VIRGINIA ELECTRIC AND POWER COMPANY
RICHMOND, VIRGINIA 23261

VIRGINIA ELECTRIC AND POWER COMPANY
NORTH ANNA POWER STATION UNITS 1 AND 2
RESPONSE TO REQUEST FOR ADDITIONAL INFORMATION
PROPOSED TECHNICAL SPECIFICATIONS CHANGES
REACTOR COOLANT SYSTEM PRESSURE/TEMPERATURE LIMITS
LTOPS SETPOINTS, AND LTOPS ENABLE TEMPERATURES

Attachment 1

Discussion of Change

Figure 3.4-2 — North Anna Unit 1
Reactor Coolant System Heatup Limitations

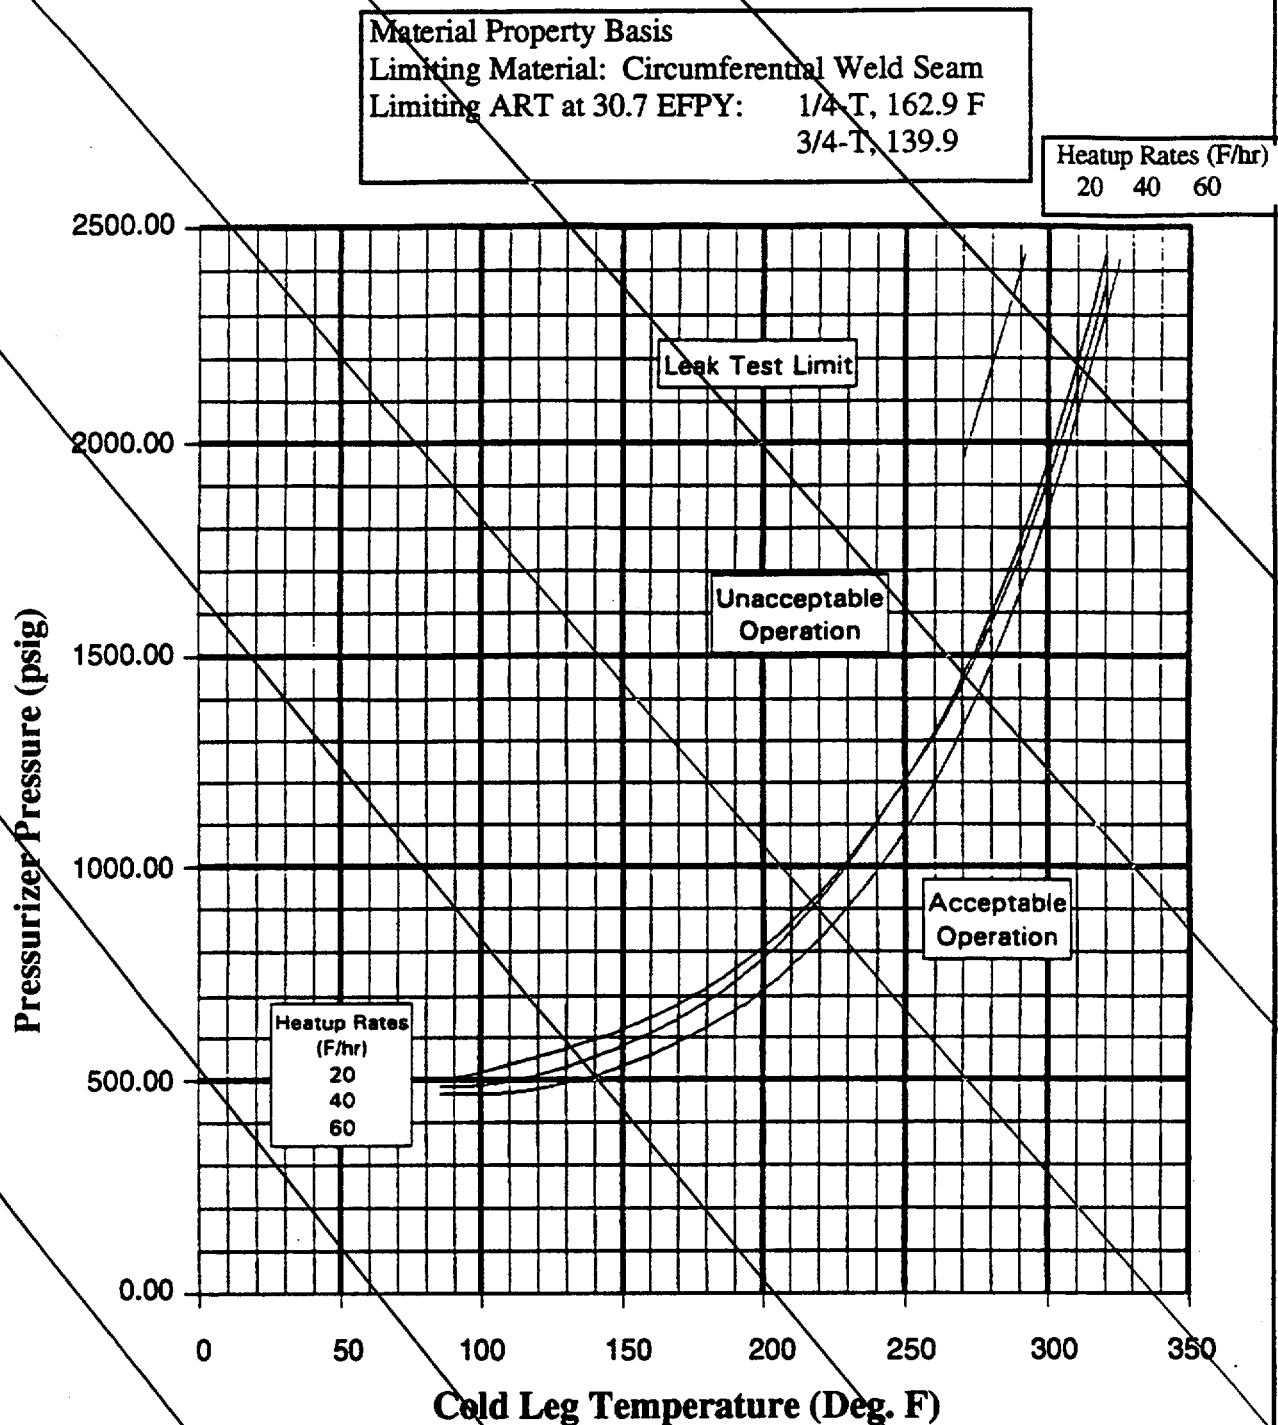
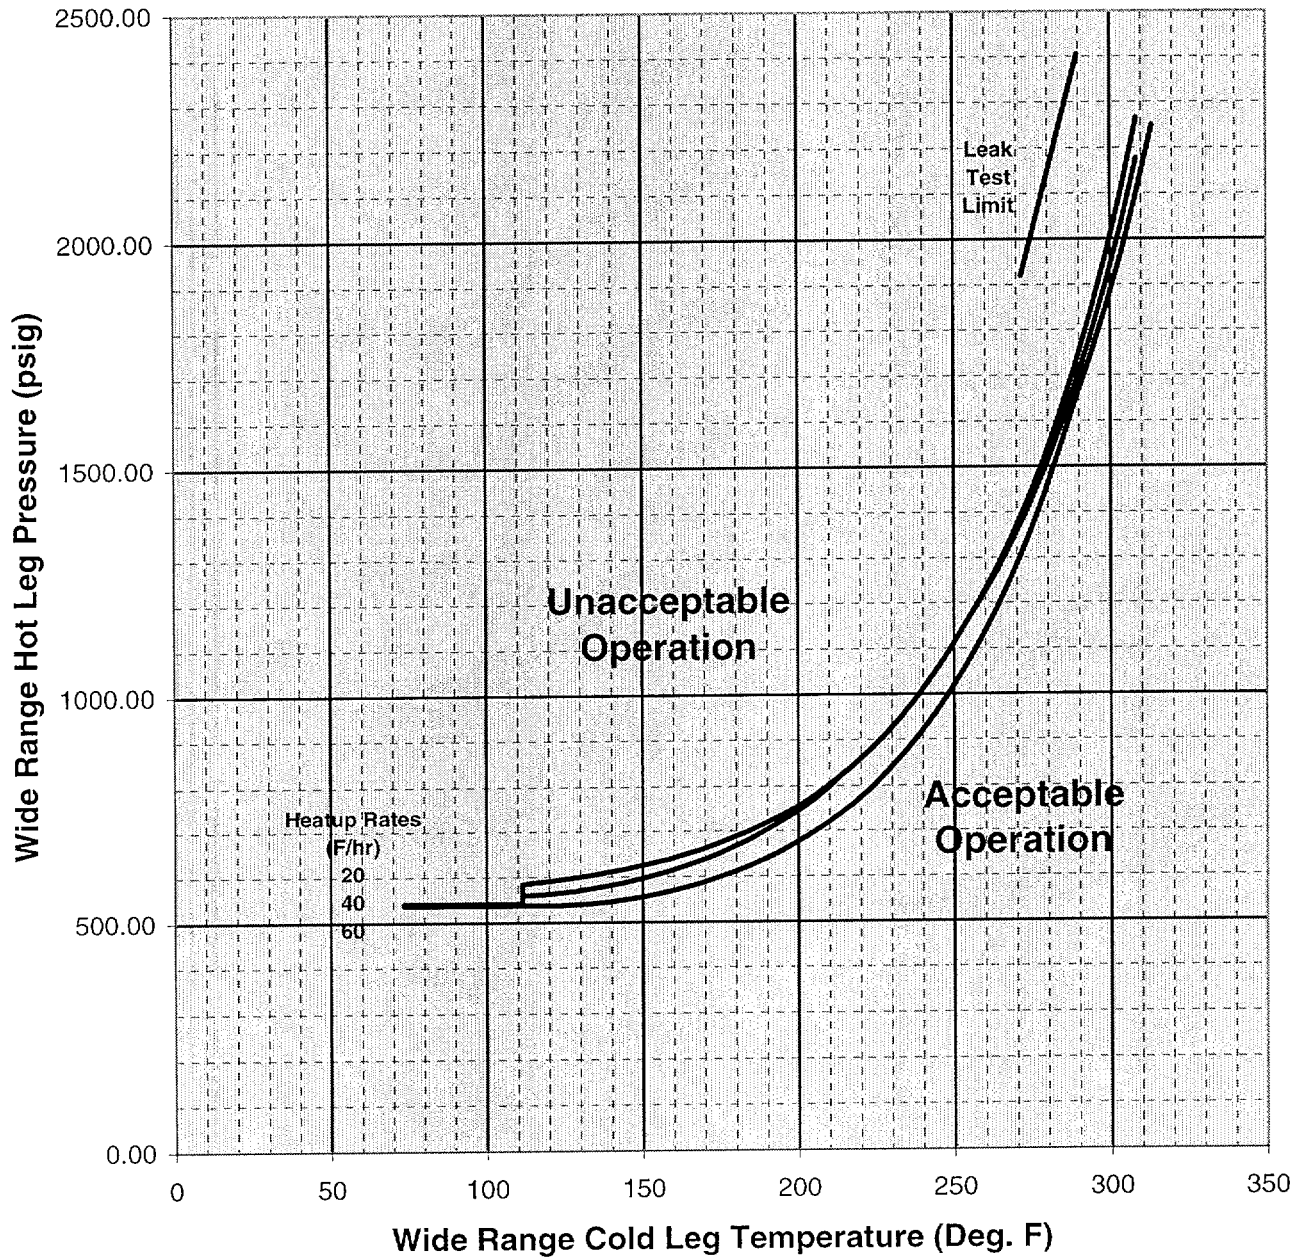
Revised North Anna Units 1 and 2 Technical Specification RCS P/T limits applicable to heatup (i.e., North Anna Units 1 and 2 Technical Specification Figures 3.4-2) were proposed in Reference [2]. The RCS P/T limits applicable to heatup presented in Appendix B replace those previously

proposed in Reference [2]. This replacement corrects the error introduced into the previously proposed curves by the computer code error described above.

Replace w/new Figure 3.4-2

Limiting ART at 32.3 EFPY: 1/4-T, 218.5 deg. F

3/4-T, 195.6 deg. F

North Anna Unit 1 Reactor Coolant System Heatup Limitations (Heatup Rates up to 60 F/hr)
Applicable for the first 32.3 EFPY (Including Margins for Instrumentation Errors)

Figure 3.4-2 — North Anna Unit 2
Reactor Coolant System Heatup Limitations

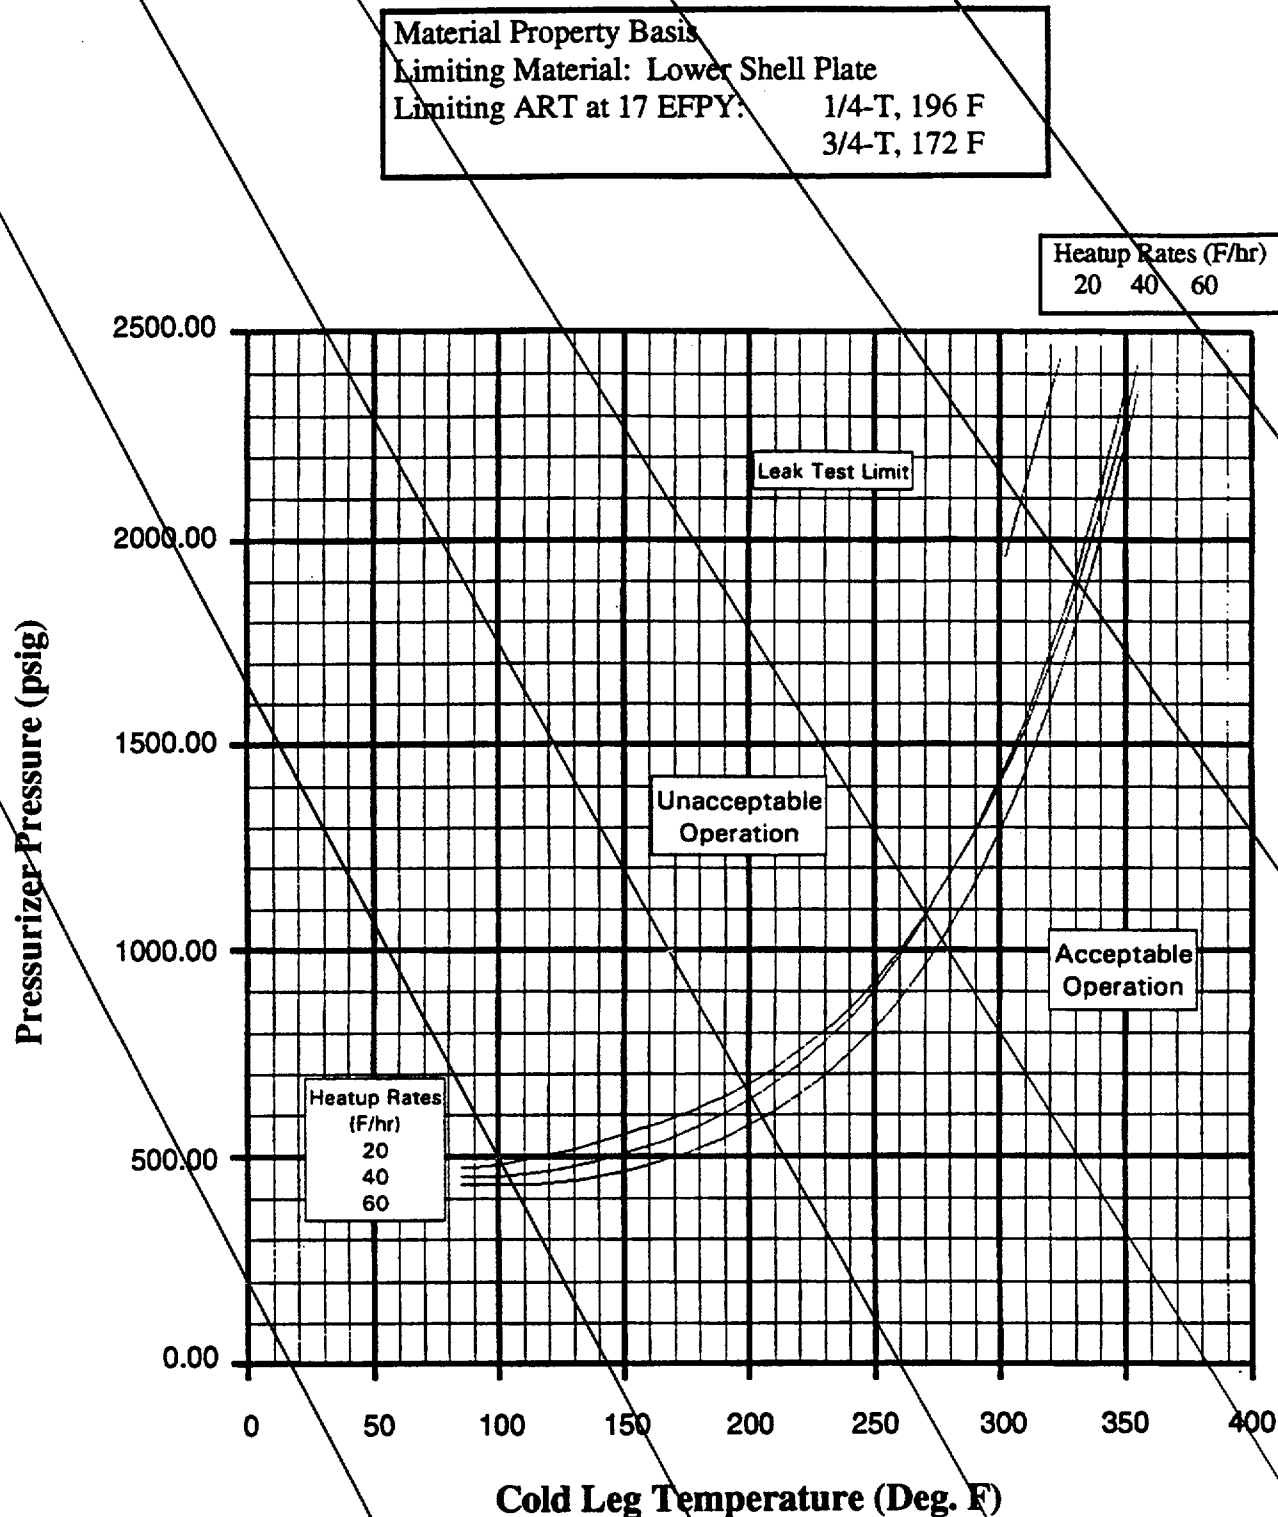
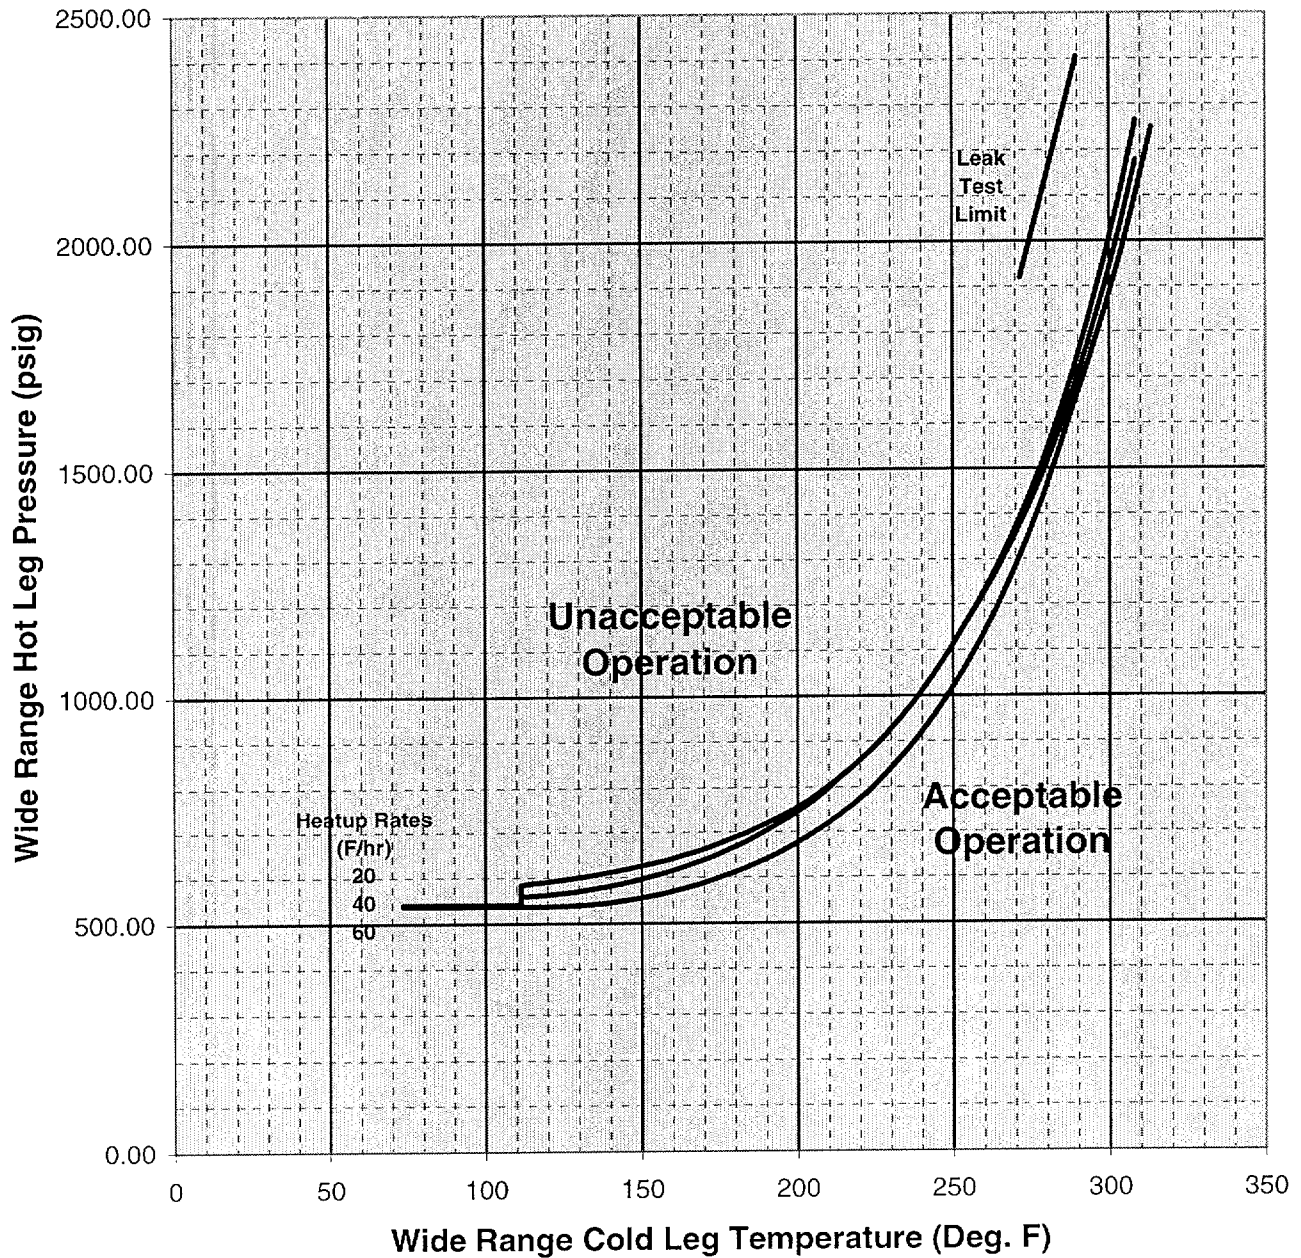
Replace w/ new Figure 3.4-2

Limiting ART at 34.3 EFPY: 1/4-T, 218.5 deg. F

3/4-T, 195.6 deg. F

North Anna Unit 2 Reactor Coolant System Heatup Limitations (Heatup Rates up to 60 F/hr)
Applicable for the first 34.3 EFPY (Including Margins for Instrumentation Errors)
